ADDENDUM #2  
Water System Improvements – Proposed Booster Pump Station  
Village of Port Sanilac  
April 24, 2024

The following clarifications and additions are to be incorporated into the construction plans, bidding and contract documents:

PREPARED FOR  
**VILLAGE OF PORT SANILAC**  
WATER SYSTEM IMPROVEMENTS  
PROPOSED BOOSTER PUMP STATION  
FOUNDATION PLAN, FRAMING PLAN & FLOOR PLAN

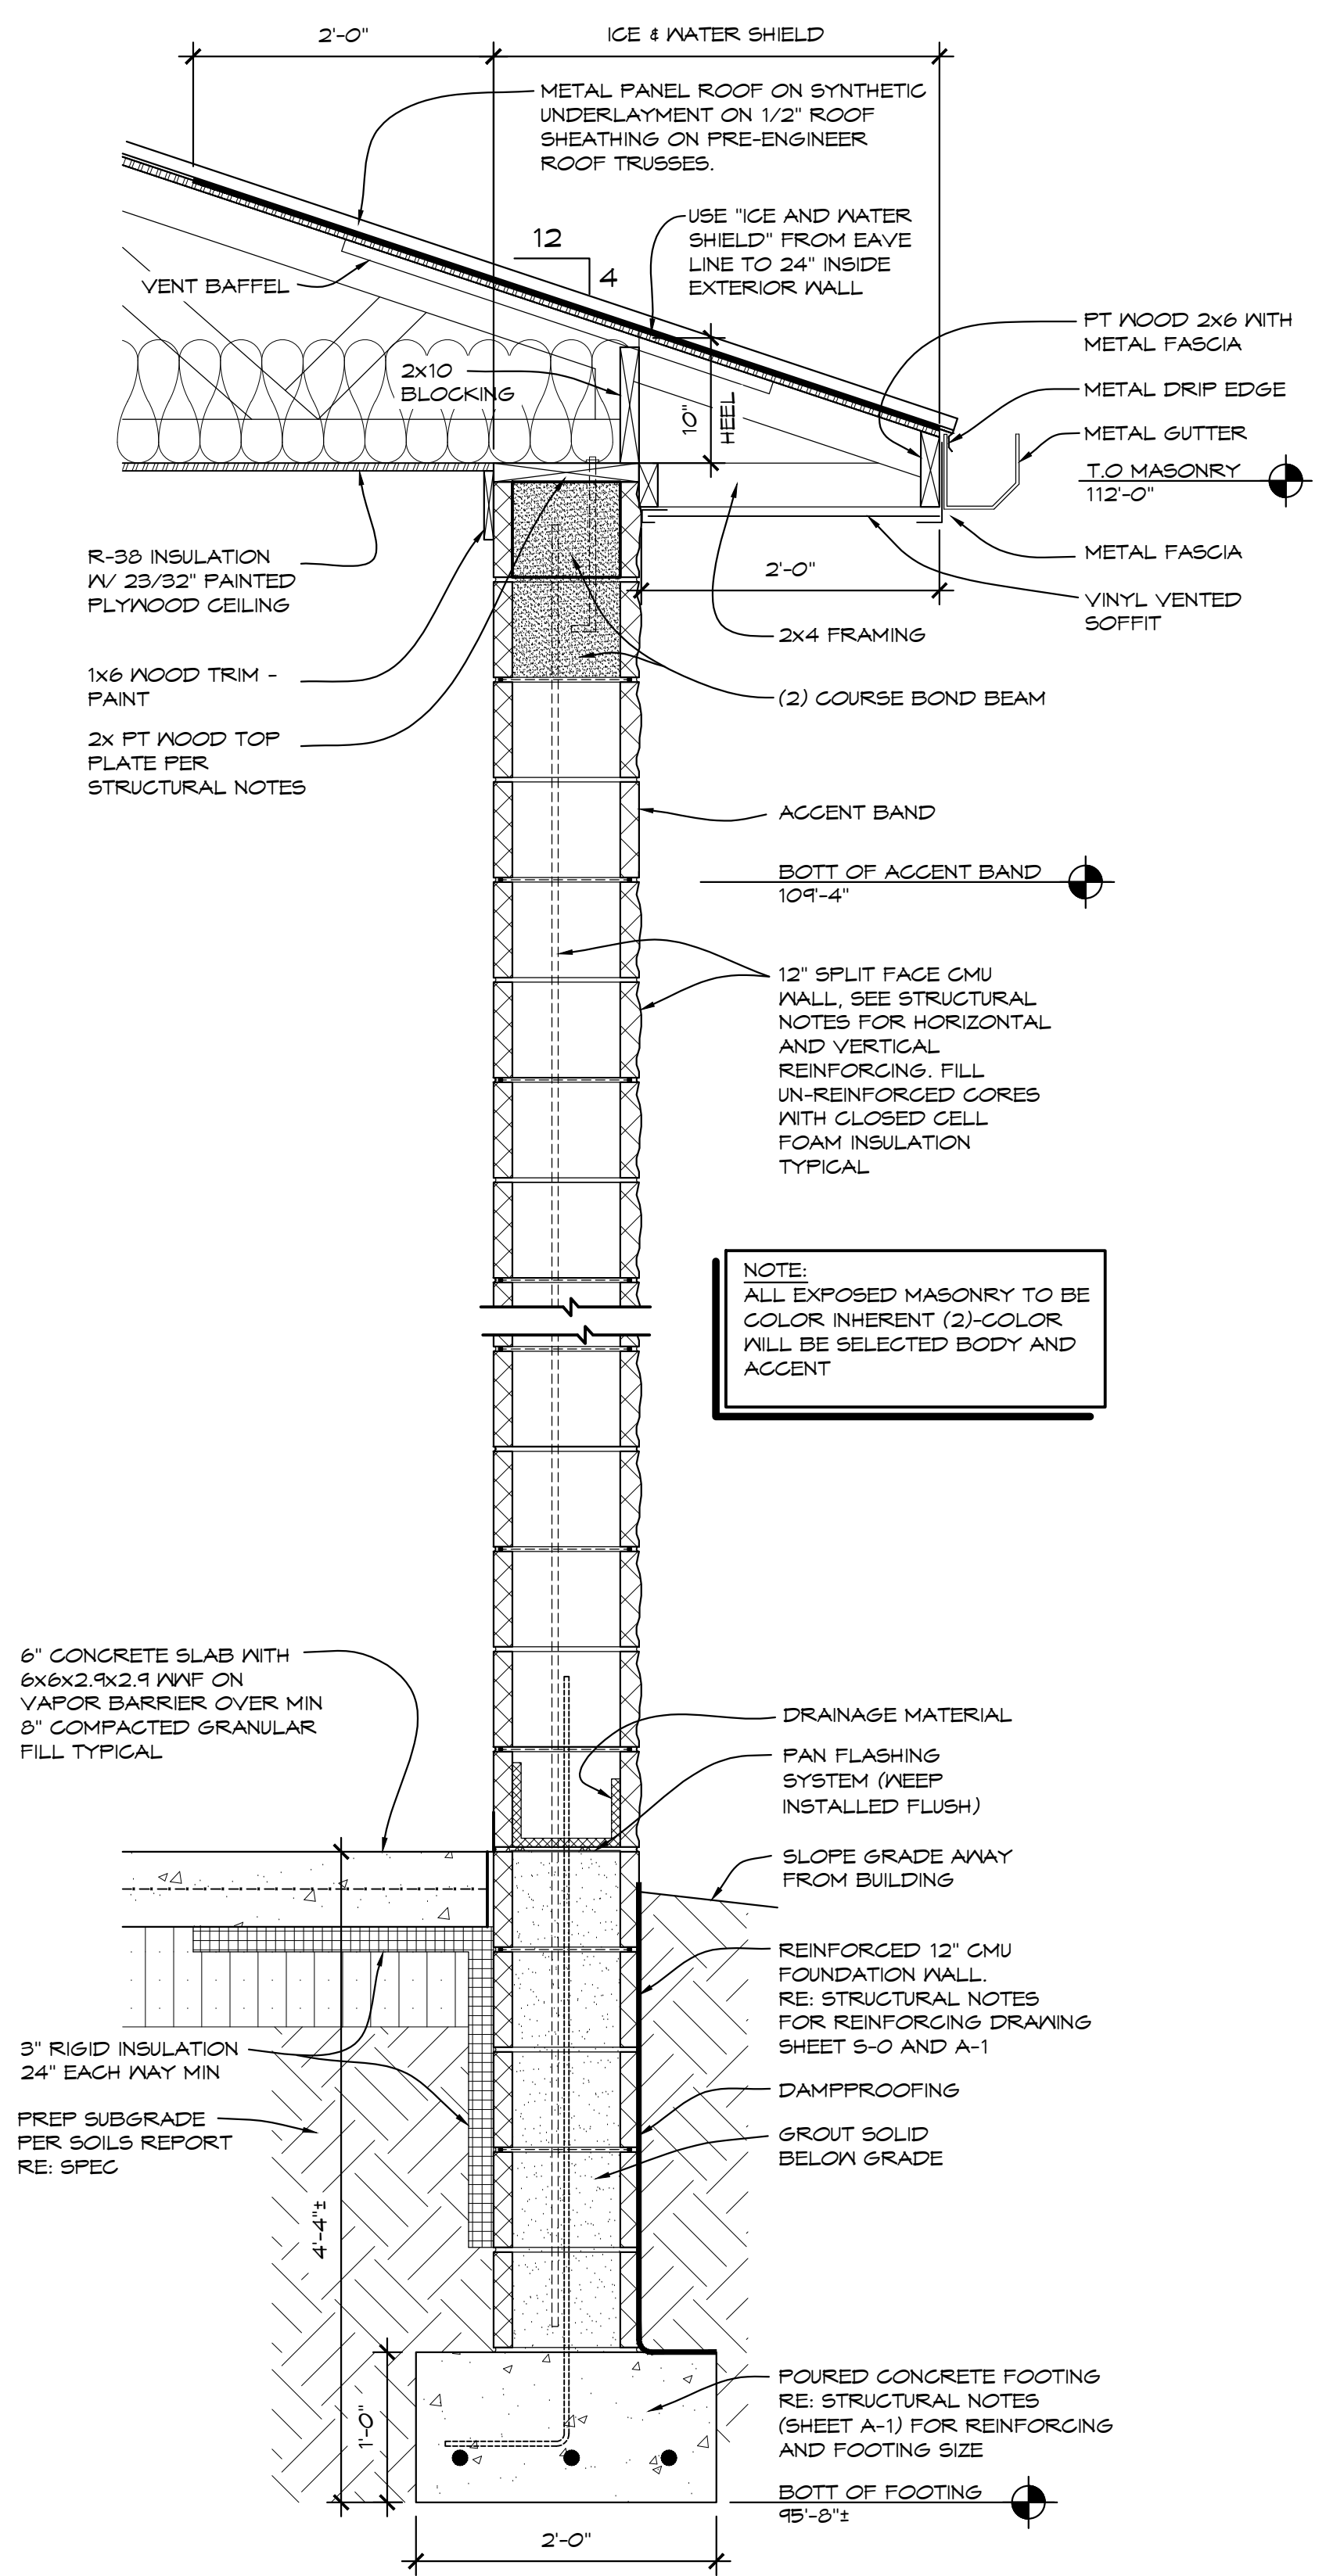
1. Refer to Drawing Sheets S-0, A-1, and A-4. (see attached)  
Lintel over door 100 and 101 has been revised, see detail 4/A-4.

LINTELS (2) COURSE MASONRY LINTEL RE: 4/A-4
